**ITEM # 6A    3/4/2021  
GREEN ACRES  
PAGE 1 OF 1  
HANDOUT #1**

From: Noel Kopperud, P.O. Box 4470, Palmer, Alaska 99645  
To: Members of the Matanuska-Susitna Borough Platting Board  
Subject: Comments on Proposed Green Acres Subdivision Master Plan, Case # 2021-006

Green Acres Subdivision

PALMER, ALASKA  
GREEN ACRES  
SITE PLAN - DESIGN  
GRADING-DRAINAGE PLAN

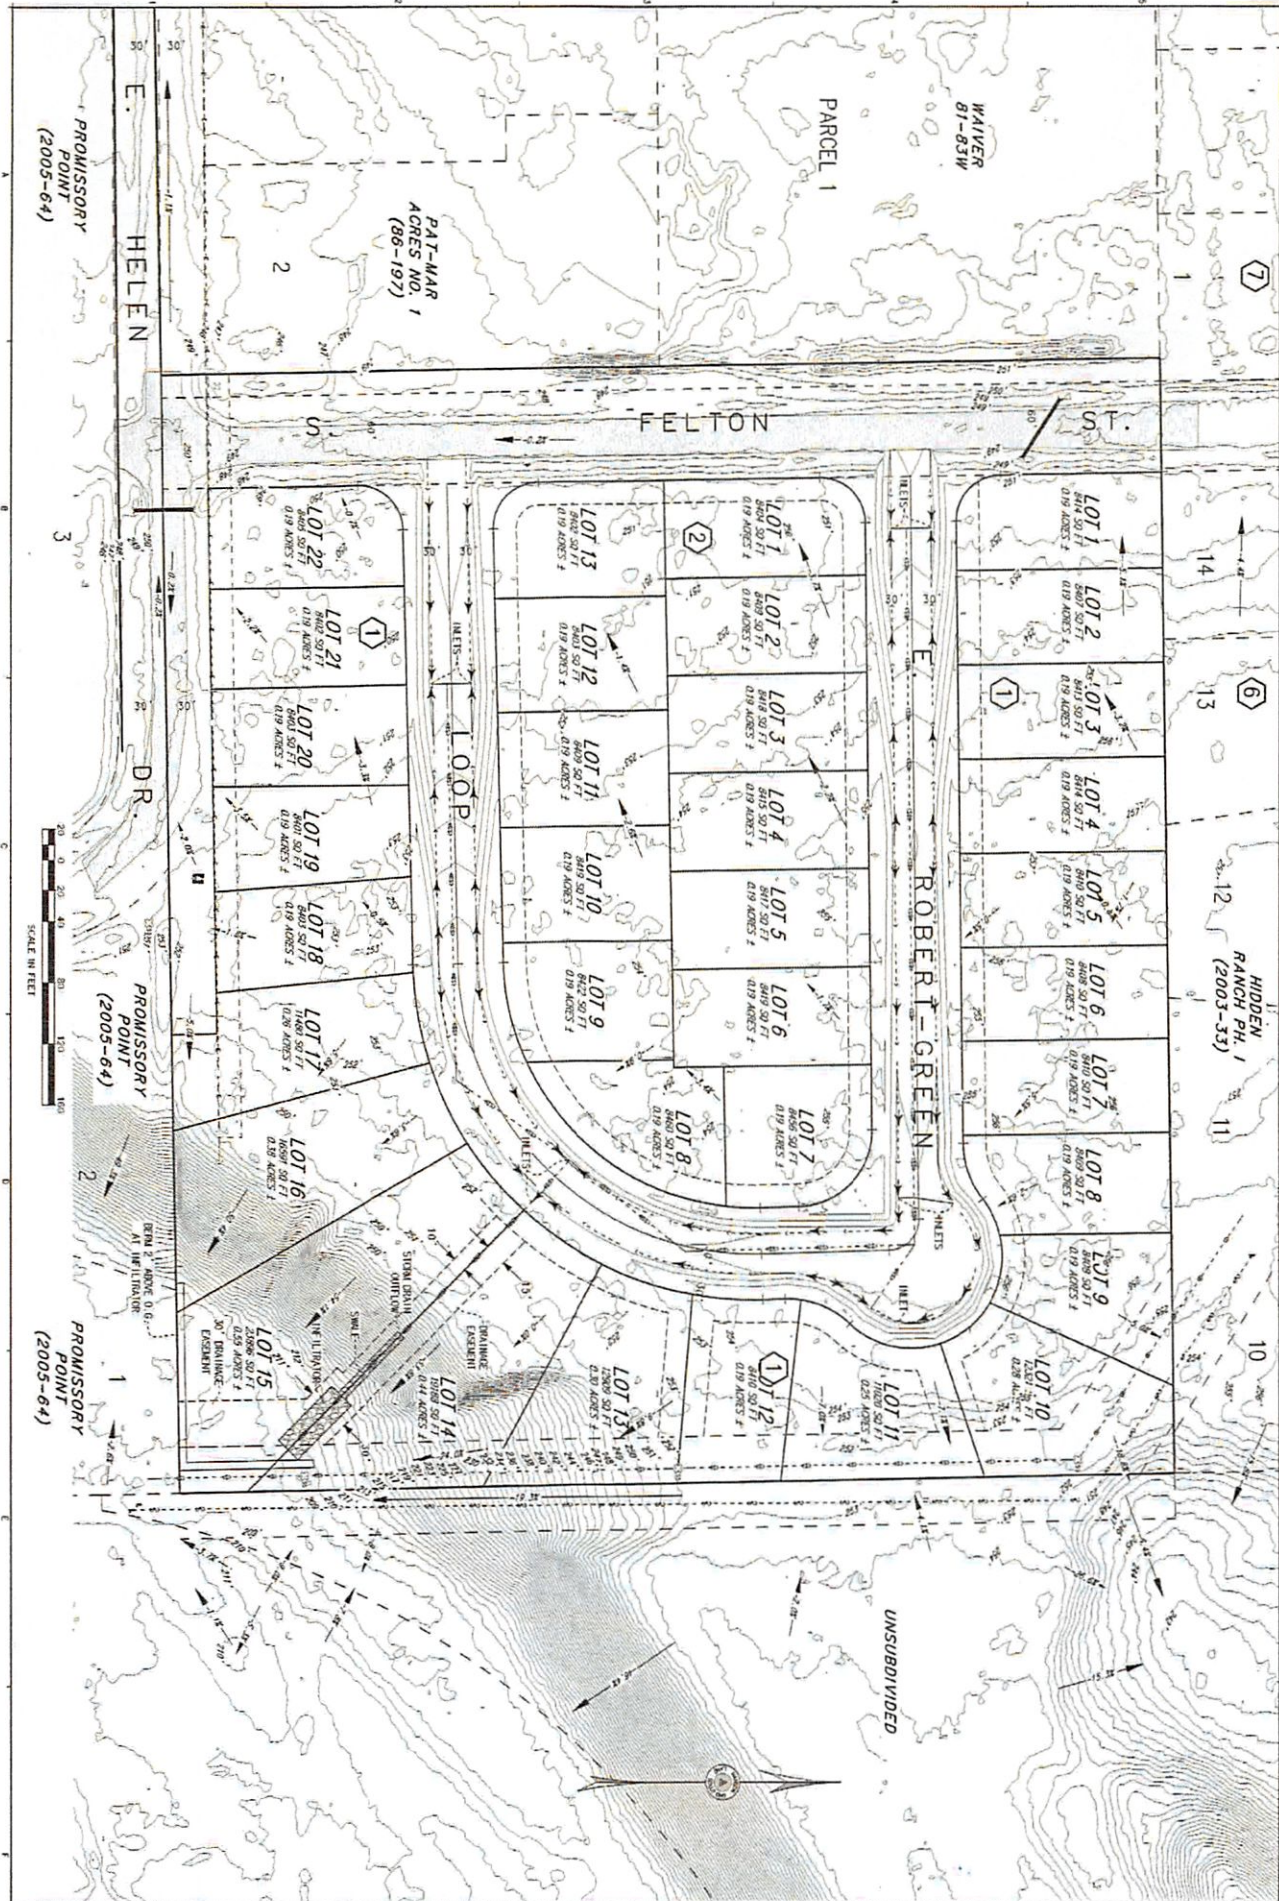
I think the stormwater drainage plan is inadequate, and that it is likely water from the subdivision is going to overflow onto my adjacent property. The stormwater plan concentrates drainage water from intensely developed upland lots and the subdivision roadway, which will then be diverted downhill to one small infiltration site on the boundary of subdivision lots 14 and 15. The hardscape, City-required curb, gutter, sidewalk, and pavement will combine with very dense housing development to assure that the 11-acre tract will generate an extreme increase in the amount of surface water. I fear that, what will actually happen, is that there will be no drainage infiltration during the eight months of the year that the ground is frozen. The overflow of diverted private surface water will be discharged on to the public sewer line right-of-way that runs in front of the planned infiltration zone. The drainage plan only shows that water escaping the infiltration zone will flow eastward and out of the subdivision.

The grading & drainage map for Green Acres, with arrows showing the expected direction of water flow, is attached as Exhibit A. I have specially marked the exhibit to show the direction of water overflowing from Green Acres on to my adjacent property (Promissory Point Lot 1).

The recently-constructed bike path along Margaret Drive (New Glen Highway frontage road from Lucas substation south behind the Noisy Goose restaurant) forms a dike or levee that will act to contain any overflow runoff water that is diverted from Green Acres downhill to the east. As Exhibit A confirms, the collected runoff water is going to flow south, along the Palmer sewer outfall main and bike path and then onto my property. The water will probably gather near the small lowland portion of Green Acres lots 14 and 15, which lie below the larger upland bluff areas of those two lots.

I have written to the City of Palmer Planning Commission and asked that approval of the Green Acres Plat be placed on hold until the City obtains an independent engineering review of the drainage plan for the subdivision. The developer has substantial onsite drainage options. The subdivision design shows no effort to accomplish water retention or maintain porosity on the upland areas. From a platting standpoint, for example, revisions could be made to the proposed current plat design to add a secondary reserve absorption or stormwater impoundment area, which would be identified by easements on the lower portions on lots 14 and 15, and elsewhere within the subdivision.

Consideration should also be given to adding appropriate plat notes that would prohibit lot owners from onsite clearing or drainage discharge that would render any designated reserve areas useless. The drainage plan changes must be made at this point in the review process, since it is evident that, once the lots pass into private ownership, the City of Palmer will have no adequate onsite space to construct anything to stop Green Acres water from overflowing onto my property.

1. On this we have now added an additional drainage easement below the one we are going to construct to retain the ability to build another one if the first should eventually fail for some reason.
2. We have also added an earthen containment dyke to the relevant corner which will be constructed prior to recording

The additional changes made here (additional drainage easement area and construction of a berm) will certainly help and we are confident this should sufficiently address the concern.

Please reference the attached calculations sheets submitted in response to the community input. System as designed has a infiltration area of 600 sf. (two 6 ft wide trenches 50 ft long). Design intent was to infiltrate the water as fast as it accumulated at the infiltrator site and detention of water was not intended. Original design was completed using what is called the Rational Method.

Also attached is a re-calculation based on the method used in the 2020 SCM, which gives basically the same results. In the new SCM, drainage volume is calculated using IDF curves in Figure D-1 and Hyetographs in Table D-2. Under these new design parameters the peak runoff amount, while greater than the effective infiltration rates are of the system 1200 sf, (utilizing the trench wall infiltration per the ADEC "5-wide" system method) can be detained by the system as designed. The excess runoff amount for this peak hour that the infiltrator is not anticipated to be capable of immediately absorbing into the soil is 1,580 cubic feet. Assuming a porosity percentage of 40% in the drain rock this would require a detention trench of 12 ft x 50 ft x 6.6 ft deep to detain this excess peak flow. This volume required for the detention is smaller than the design depth of 8 ft shown in the project plans.

Additionally, to accommodate the understandable concern, our revised drainage plan has been modified to show an additional drainage easement area to be provided that is sufficient to hold an entirely new infiltrator in case the original one becomes ineffective. Additionally, the drainage plan now specifies that a 2' height berm will be built downstream from the infiltrator area creating a closed basin that exceeds the total calculated 24 hour storm event runoff from a 10 year storm using the numbers outlined in the SCM.
